**REPUBLIC OF INDONESIA
MINISTRY OF PUBLIC WORKS
DIRECTORATE GENERAL OF HIGHWAYS
DIRECTORATE OF PLANNING**

**KARAWANG BYPASS
ROAD SAFETY AUDIT REPORT
As Constructed**

January 2011

Intersection No. 02 Sta 11+475

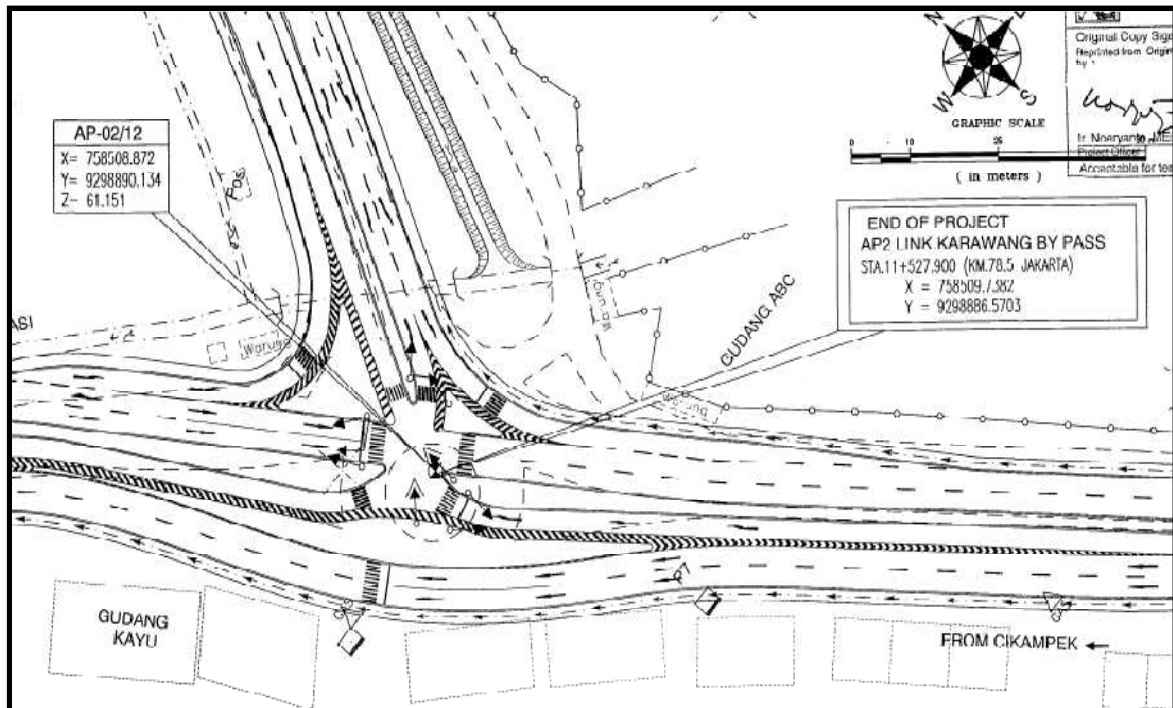
The proposed design included new signal equipment, islands, footways, pedestrian barriers. The junction is still very unsafe for pedestrians and much of the signal equipment is not working or damaged, see photos below:

The traffic signal lamps were not working or not bright

Pedestrian Crossing was blocked by Traffic Signal poles

Drainage at the Islands is exposed and hazardous to pedestrians

Height and size of signal head for warning light is not standard and is not working

Traffic lights are not working and one pointing in wrong direction

Public transport is picking up the passengers but the pedestrian paths are not constructed for safety

Additional Problem: No rumble strips on approaches to the junction.

- Add rumble bars to all approaches
- Ensure all broken signal equipment repaired promptly
- Upgrade main signal head on each approach to large high visibility specification, (see photo below)
